Manitoba Clean Environment Commission
Hearing for the Vivian Silica Sand Extraction Project (Project)
Sio Silica Corporation (SSC) Responses to Information Requests (IRs) Round No. 2

IR Number: DLN-IR-001

Submitted by: DLN

Date Submitted: January 5, 2023

Figure 2. Air entrained in by the overflow v notch weir and the receiving pool of a clarifier tank⁷

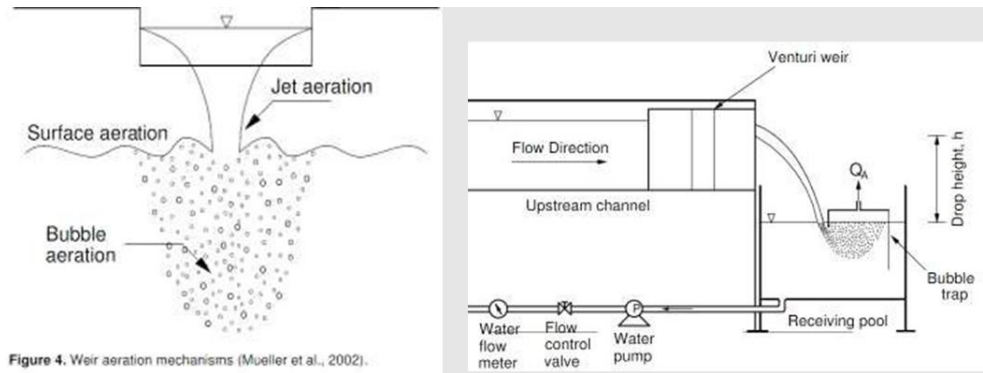
Entrained air in the process wastewater as documented in DLN IR 002 is major issue overlooked by Sio Silica. Further evidence of air entrainment in a clarifier by the V notch overflow weir of the clarifier and in effluent water plunging into a process water receiving tank is illustrated in figure 2.^{7,8}

27. The water in the frac tanks will contain large amounts of entrained gaseous air as illustrated by the aerated water jet filling the frac tanks show in figure 1. The water plunging into the tank would entrain more air.⁶ Bubbles of entrained gaseous air when injected into the aquifer at year end would rise, enter the carbonate aquifer through the degraded shale, spread rapidly through the water bearing fractures of the carbonate aquifer causing precipitation iron and manganese and fostering the proliferation of well- fouling iron bacteria. The degradation of the shale aquitard is modelled in the Hydrogeological Report. The precipitation of iron and manganese due to oxidizing conditions and the proliferation of iron from the aerated water is documented in the public comments for the Extraction EAP by Dr. E. Pip. Please clarify why this re-injection of vessel and slurry line water at Project year end would not contradict the statement in response (h), *"Sio similarly does not expect any adverse impacts on local water supplies from extraction activities."*

28. The entrained air in the process water would be in all the water re-injected into the sandstone aquifer throughout the extraction process, not just at year end. Air would be entrained in the clarifier tanks and hydrocyclones used for the UV filtration systems. For example air would be entrained in plunging water from the v notch overflow weir in the clarifier and in the plunging water entering the collection tank for the wastes water from the clarifier as illustrated in Figure 2.^{7,8} Hydrocyclones have an air core as illustrated and documented in DLN IR 002 that would entrain gaseous air. Please clarify why the adverse impacts of re-injection of water containing entrained gaseous air described in request for clarification 16, that would occur throughout the Project year, would not contradict the statement in response (h), *"Sio similarly does not expect any adverse impacts on local water supplies from extraction activities"*

27. The Groundwater Monitoring and Mitigation Plan will monitor groundwater in the formation and prior to re-injection for a suite of parameters to confirm the extraction process is performing as expected. The system will be designed to minimize the possibility for proliferation of bacteria. The supply of oxygen to the aquifer will not be unlimited and will therefore not allow for complete oxidation of any reduced form minerals.

28. The Groundwater Monitoring and Mitigation Plan will monitor groundwater in the formation and prior to re-injection for a suite of parameters to confirm the extraction process is performing as expected. The system will be designed to minimize the possibility for proliferation of bacteria. The supply of oxygen to the aquifer will not be unlimited and will therefore not allow for complete oxidation of any reduced form minerals.
